Reference: 265 Bridgeport Avenue, Shelton, Connecticut

In this letter, I'm responding to traffic comments from SLR dated May 17, 2022.

TRUCK TURNING MOVEMENTS EXHIBIT
265 BRIDGEPORT AVENUE & 3 COTS STREET
SHELTON, CT

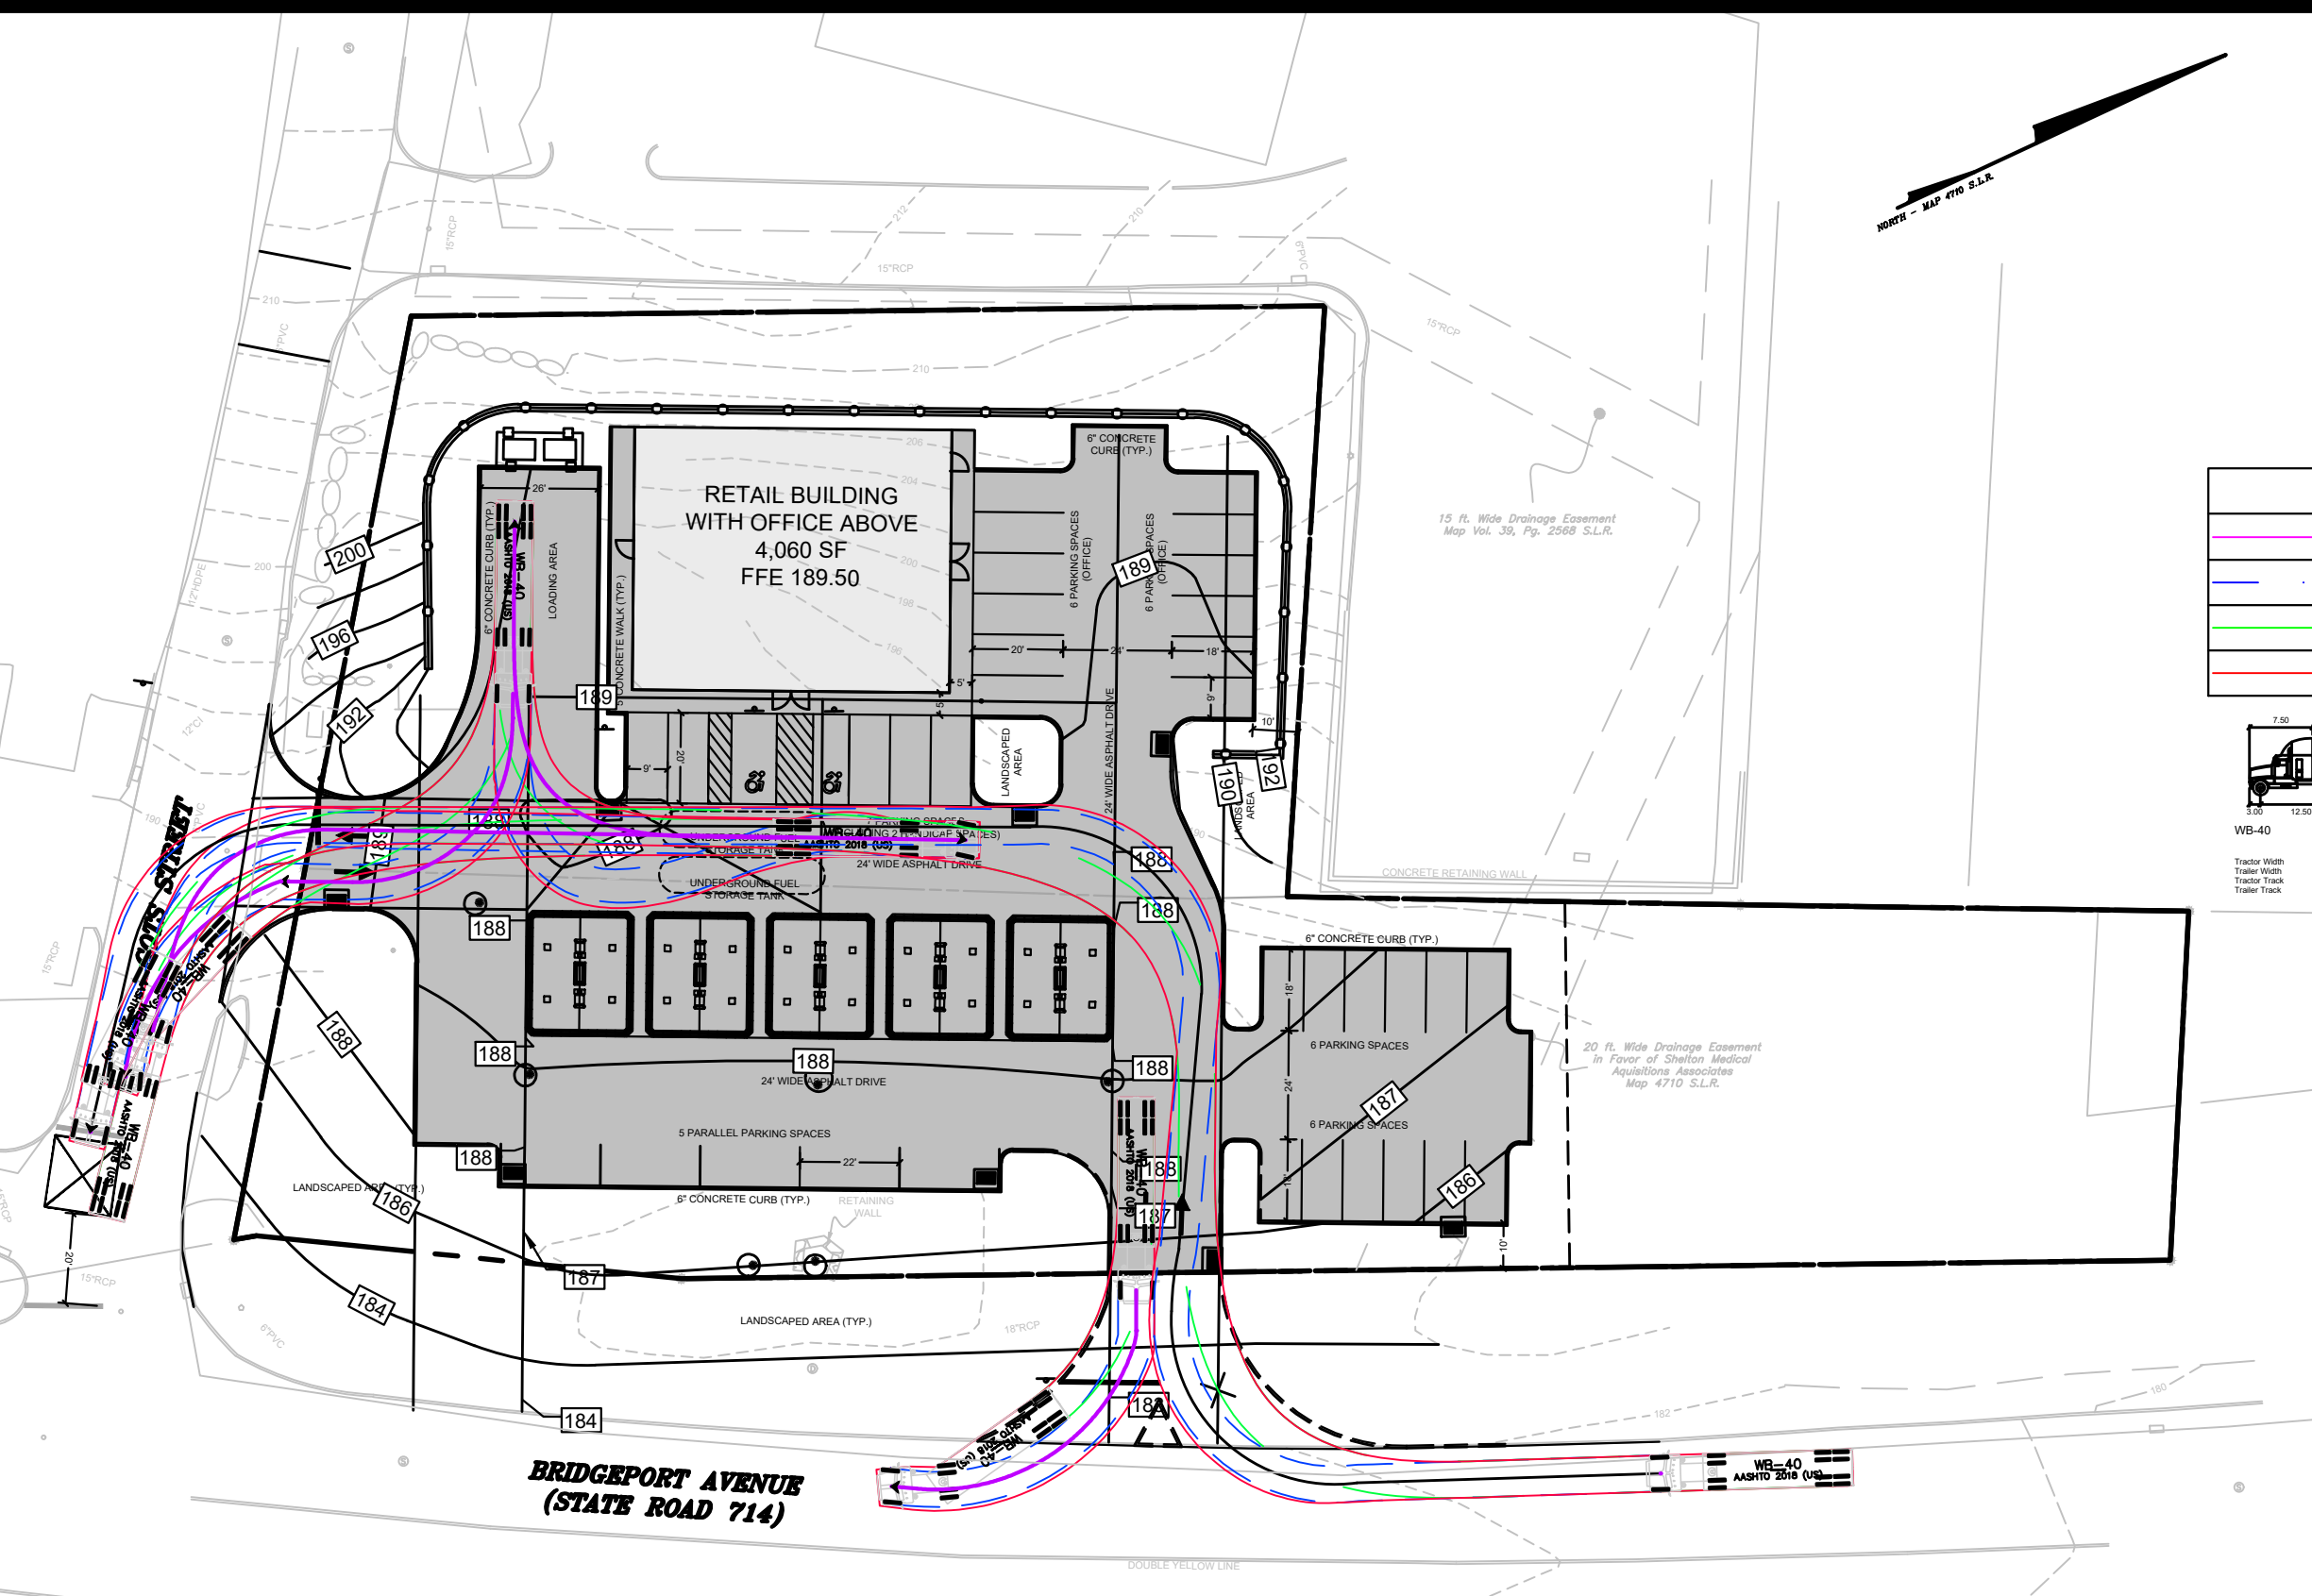
SLR Comment: *The WB-40 turning right into the site from Bridgeport Avenue is shown to use both travel lanes along Bridgeport Avenue. The turning template should demonstrate the WB-40 vehicle turning right into the site from the right-most travel lane on Bridgeport Avenue without using the second, inside, travel lane. Additionally, the turning template shows that the truck clips the corner of what appears to be the northwestern gas station canopy. Please address.*

Response: Revised. Refer to the updated exhibit.

SHEET No: **SE-1**

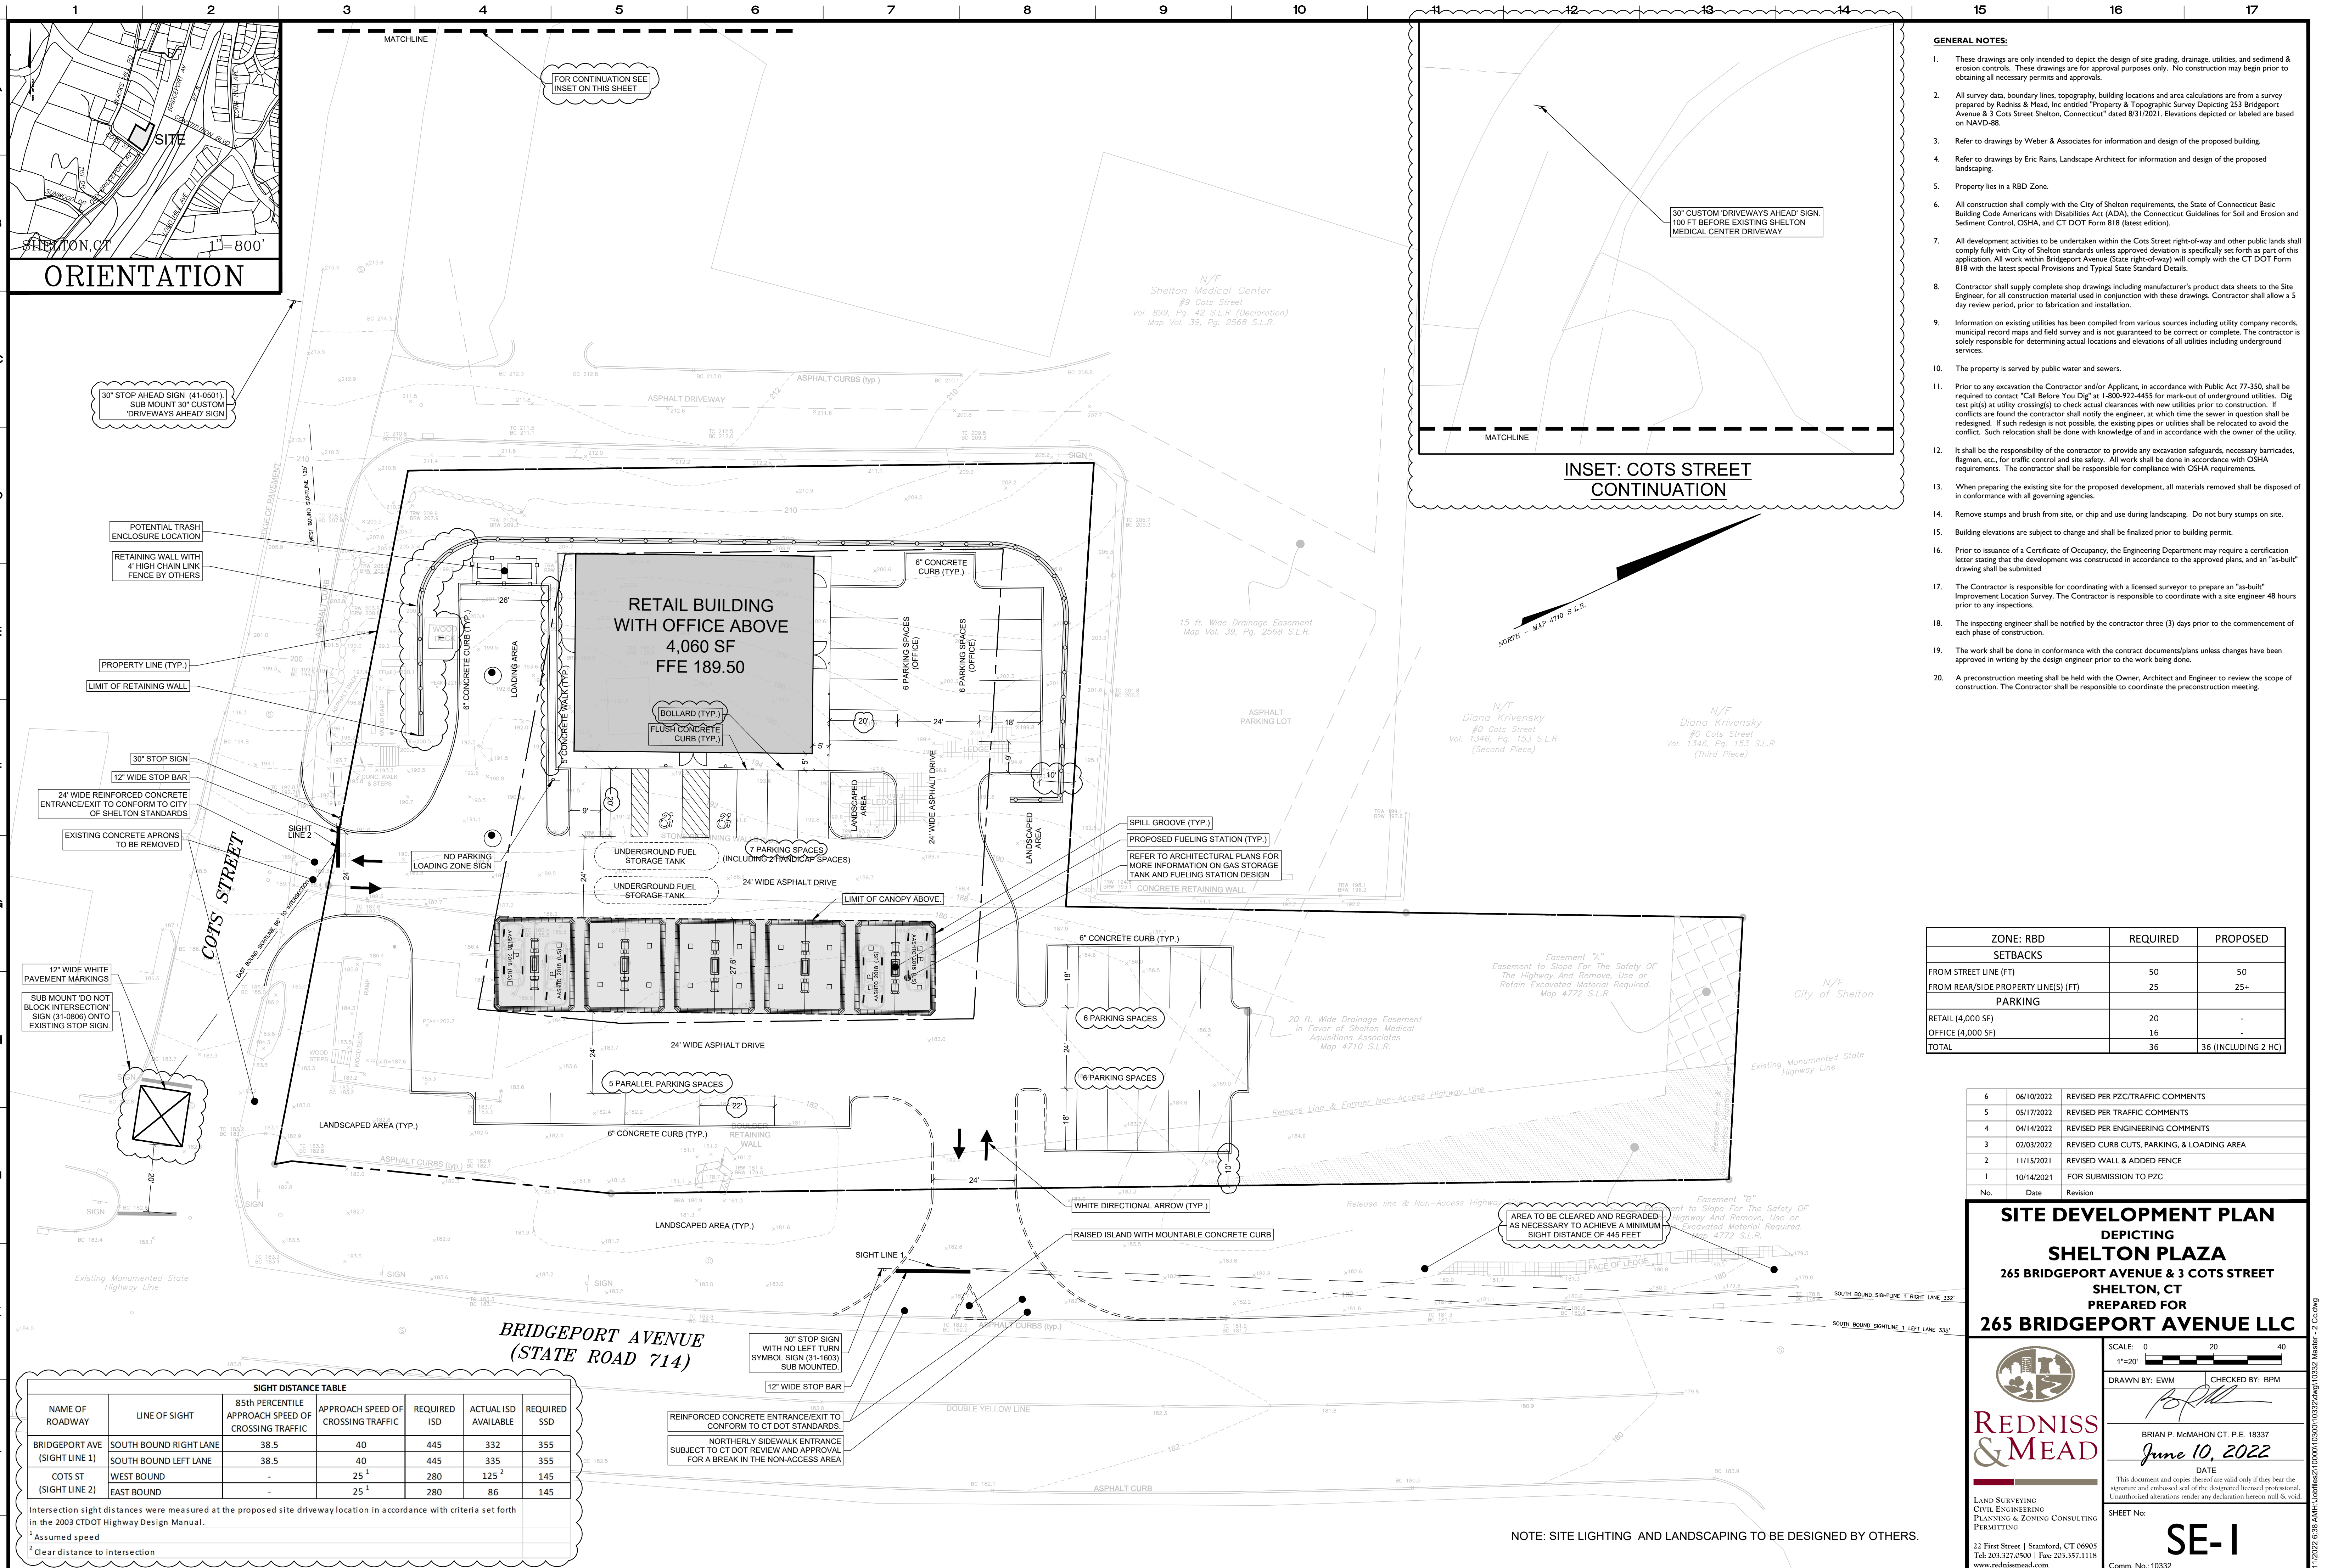
SLR Comment: *Please see the attached mark-ups of the site plan showing “do not block intersection” pavement markings. This modification to Cots Street would be adequate to prevent blocked access to Old Bridgeport Avenue.*

SLR Comment: *“Sight Line 1” is 15 feet from Bridgeport Avenue at the right-out-only egress and indicates 332 feet is available. For the posted speed limit, 40 mph, 445 feet of intersection sight distance (ISD) is required based on CTDOT guidelines. The 85th percentile speed, if available, would likely be faster than posted. Please provide a complete sight line analysis in both graphic and tabular form showing the posted and 85th percentile requirements and the available sight distance. If necessary, a stopping sight distance (SSD) analysis should be provided if ISD is not achievable.*

Please explain what "Sight Line 2" is showing. It appears it is being measured from some 30 or more feet back from Bridgeport Avenue.

The sight line from the Cots Street site egress looking to the left is clear to the Bridgeport Avenue intersection. The sight line looking to the right indicates there is 125 feet available in that direction. For an assumed travel speed of 25 mph, 280 feet of ISD is required per CTDOT guidelines. Please provide a complete sight line analysis for the Cots Street egress similar to that requested for the Bridgeport Avenue egress.

Response: Revised. Refer to the attached Site plan sheet SE-1.

Response: Sight Distance Table and additional advance warning signs have been added to sheet SE-1. "Sight line 2" on Bridgeport Ave has been removed from the plan.

The proposed warning signs on Cots Street include one stop ahead sign (41-0501) and a custom 30"x30" diamond sign with yellow background and black copy "DRIVEWAYS AHEAD" on one post west of the proposed site driveway and facing eastbound traffic on Cots Street. Another 30"x30" diamond sign with yellow background and black copy "DRIVEWAYS AHEAD" is proposed about 180 feet to the west, facing eastbound traffic on Cots Street.

The sight line conditions looking north along Bridgeport Avenue will improve with the reconstruction of the intersection of Bridgeport Avenue and Constitution Boulevard West. In the interim before the Constitution Boulevard West intersection is constructed, we recommend that area along Bridgeport Avenue be cleared and regraded as necessary to achieve a minimum sight distance of 445 feet.
